**REMEDIAL SYSTEM EVALUATION**

**AMERICAN CREOSOTE WORKS SITE  
PENSACOLA, FLORIDA**

Report of the Remedial System Evaluation  
Site Visit Conducted  
October 5, 2005

Final Report  
June 27, 2006

FIGURE 1-1. SITE PLAN.

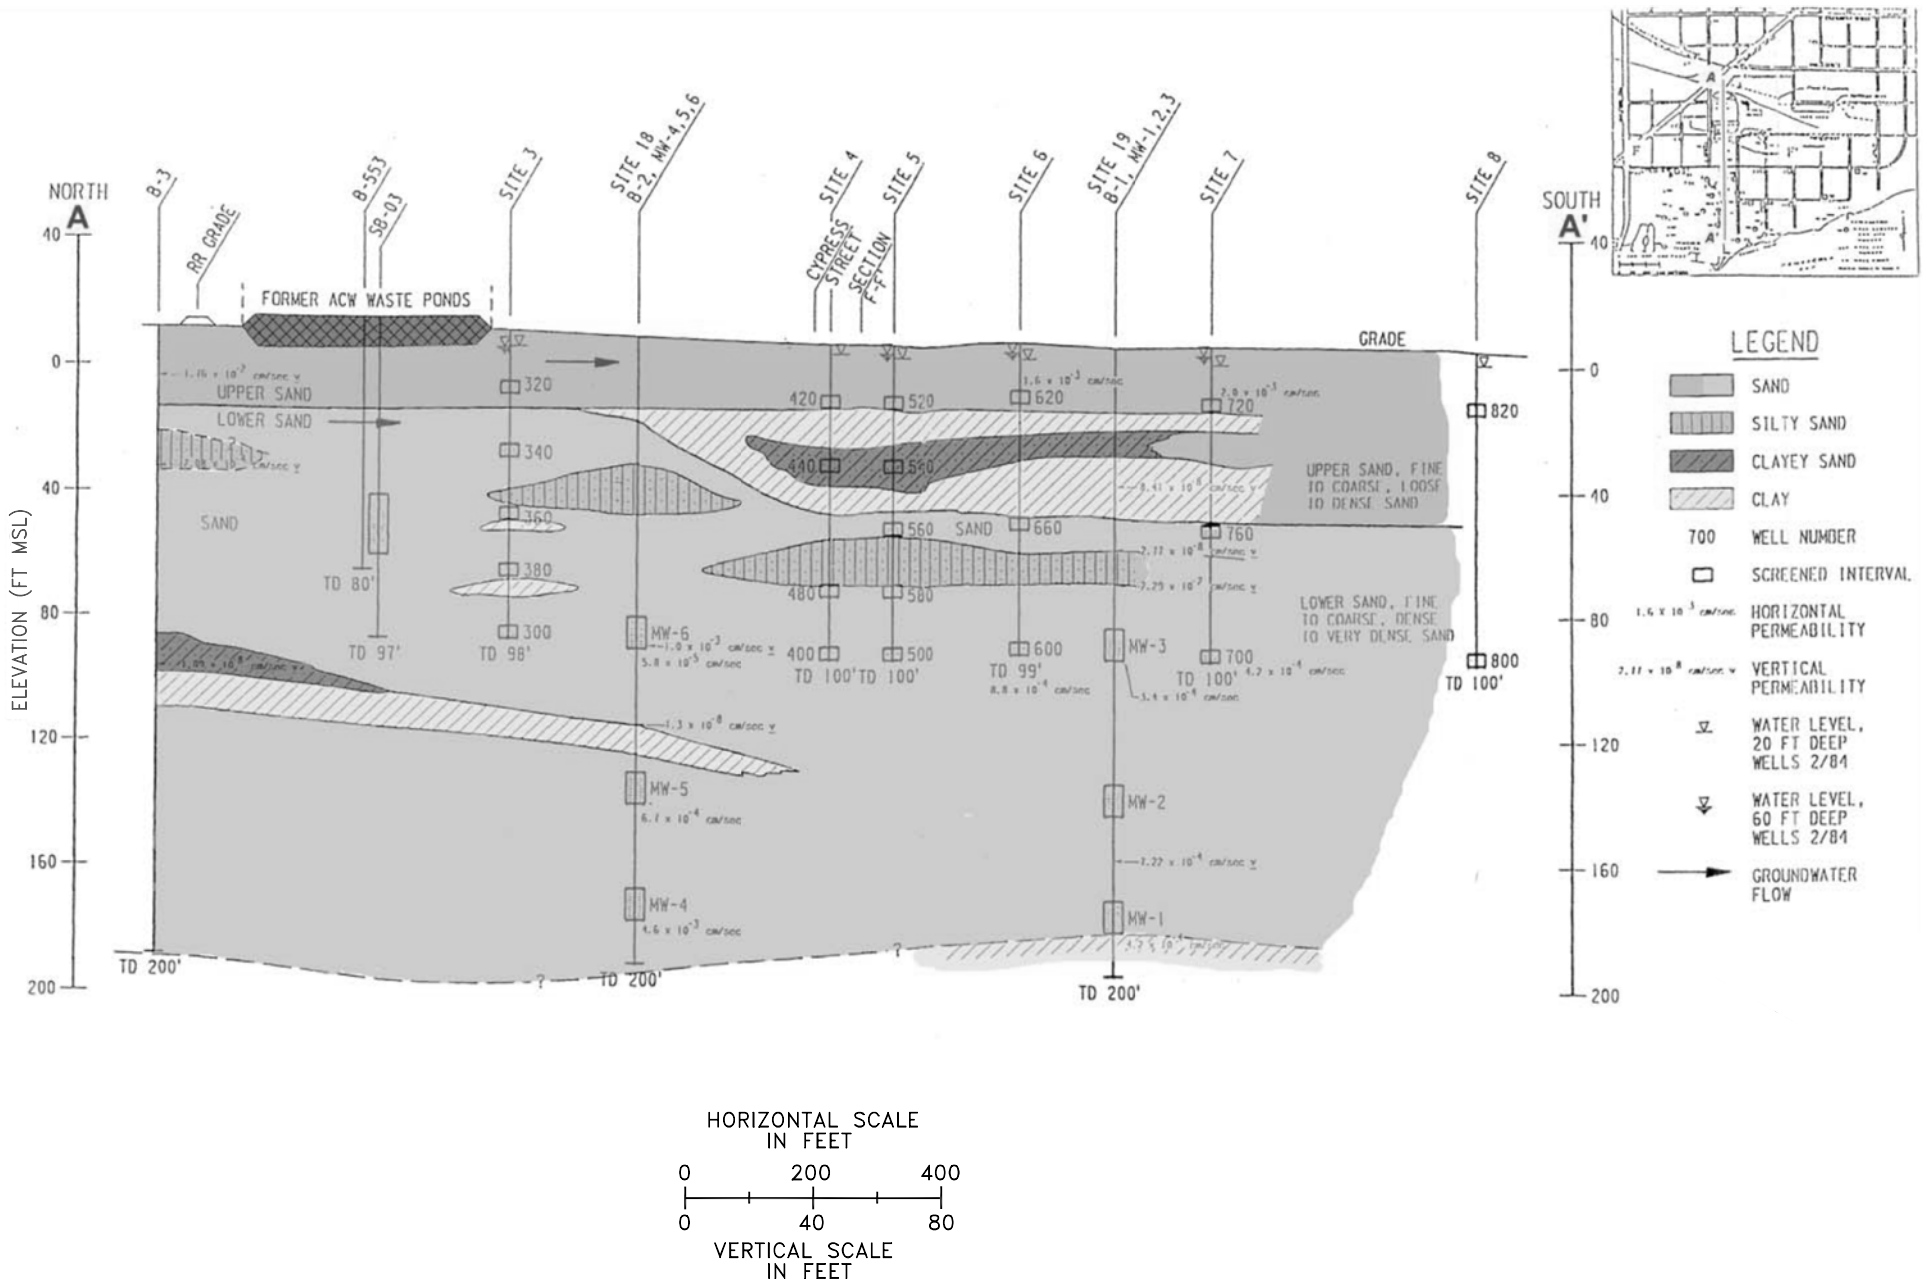
The ACW site is located on 1800 Gimble Street on the abandoned American Creosote Works wood preserving plant in Pensacola, Florida. The site is approximately 18 acres in area. The site is bounded by Gimble Street to the north, F Street to the east, Pine Street and an apartment condominium complex to the South, and L Street to the west. A lumber company, an auto body shop, a produce distributor, and an appliance sales and repair shop lie to the north of the site, residential areas are to the south and east, and the Pensacola Yacht Club (PYC) lies to the southwest of the site. The site is about 600 yards north of Pensacola Bay and Bayou Chico. A site plan is included as Figure 1-1.

FIGURE 1-2. NORTH SOUTH GEOLOGIC CROSS SECTION (BECHTEL, 1996)

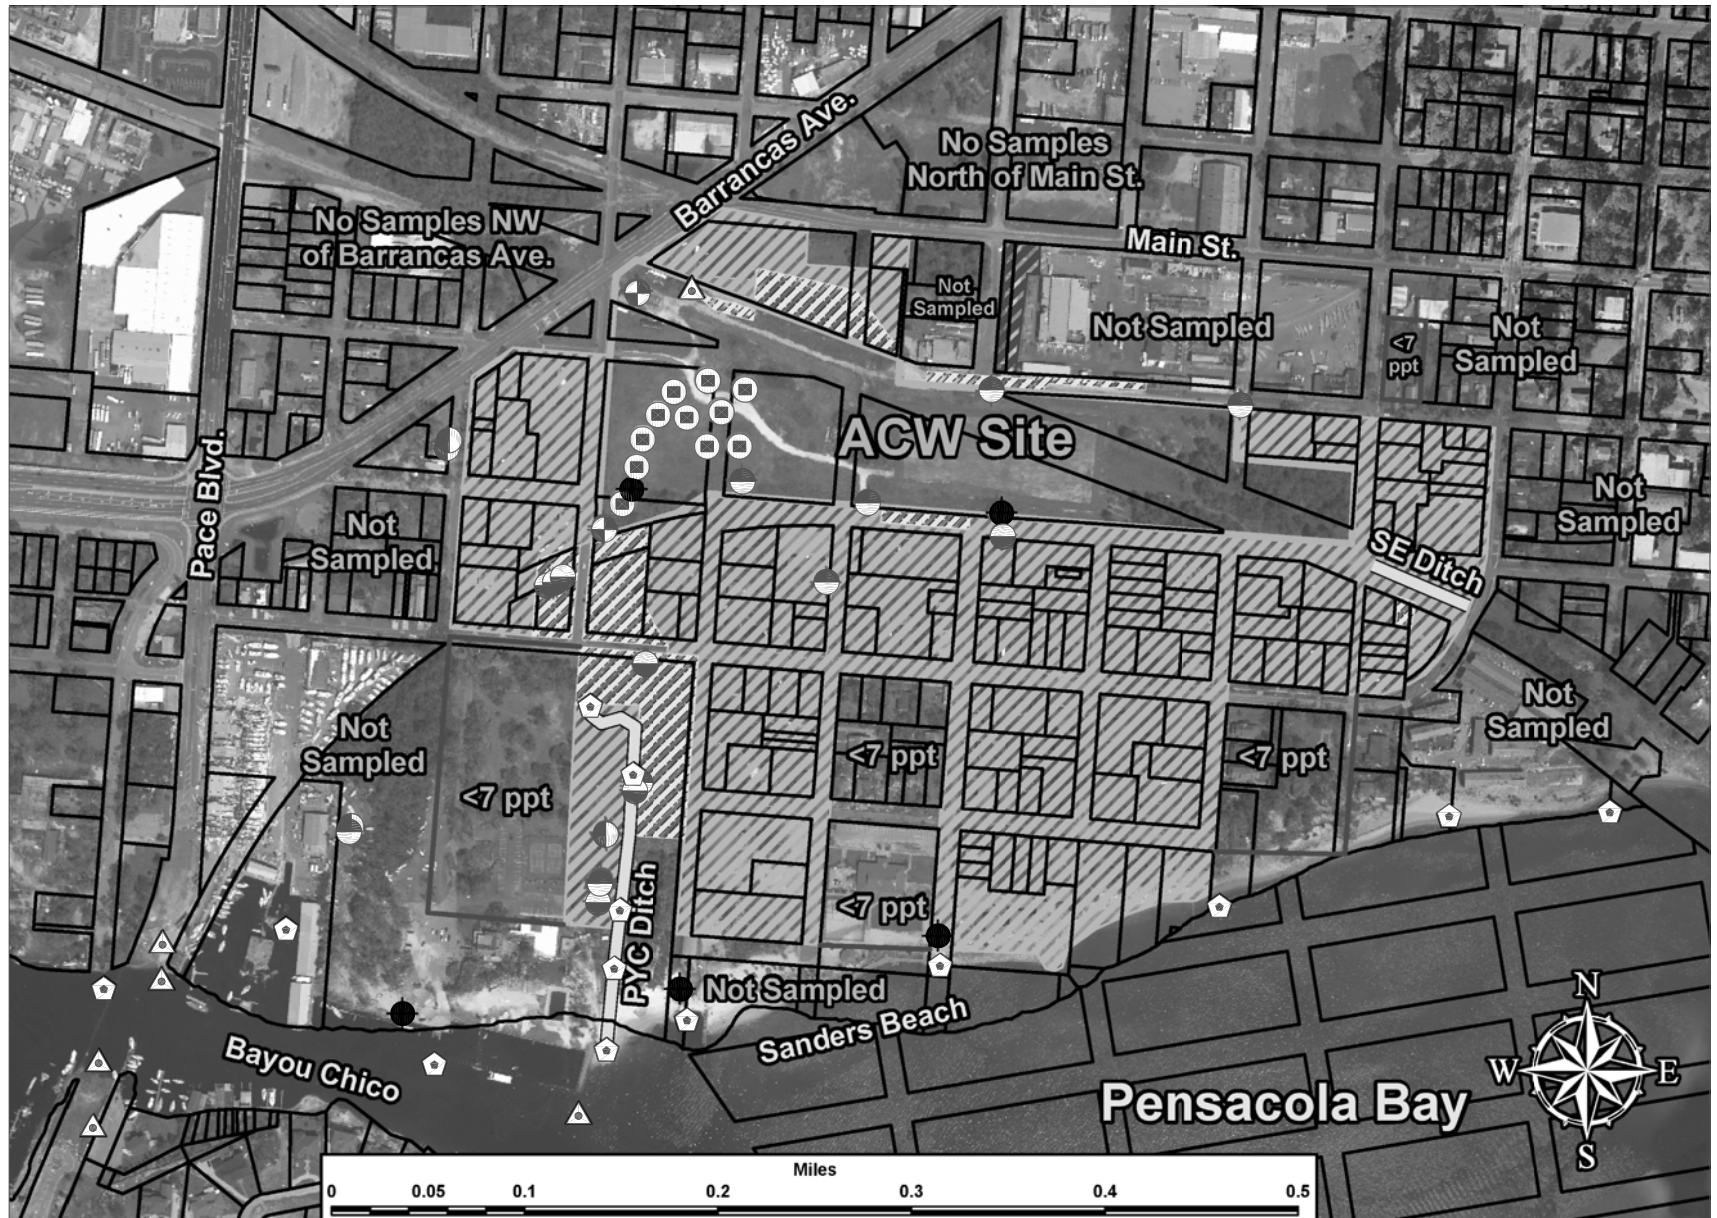
Pensacola lies within the Coastal Lowlands, which consist mainly of sand and gravel. This aquifer is exposed at the surface and deepens to as much as 1,100 feet below ground surface. The upper 25 feet of the ACW site consists of fine to coarse sand. From about 25 feet to 200 feet below ground surface there is very dense sand, fine to medium grained, with interbedded silt and clay nodules and lenses. There is a clay layer directly under the ACW ponds at about 100 feet below ground surface. The Pensacola Clay underlies the sand and gravel aquifer at approximately 200 feet below ground surface and is approximately 250 to 300 feet thick, reportedly providing a hydraulic barrier to vertical contaminant migration. Based on the characteristics of the sands, the water-bearing zone can be divided into two distinct strata identified as the upper and lower sand. The upper sand extends to approximately 25 or 30 feet below ground surface. Representative hydraulic properties for the upper sand include a horizontal hydraulic conductivity of  $10^{-3}$  cm/s (approximately 3 feet/day) and a hydraulic gradient magnitude of 0.003. South of the site, a clay layer up to 38 feet thick underlies the Pensacola Yacht Club property beginning at a depth of about 20 feet. This clay layer extends south toward Pensacola Bay. The lower sand extends from 30 feet below ground surface to 200 feet below ground surface. Representative hydraulic conductivities for the lower sand from the Remedial Investigation range from  $3.4 \times 10^{-4}$  cm/sec to  $4.6 \times 10^{-4}$  cm/sec. A representative hydraulic gradient magnitude is 0.0016. Ground water flow direction at the ACW site in the lower sand zones is to the southwest. In the upper sand, ground water flow direction is to the southwest on the western part of the site and southeast on the eastern part of the site. A north-south geologic cross-section is included as Figure 1-2.
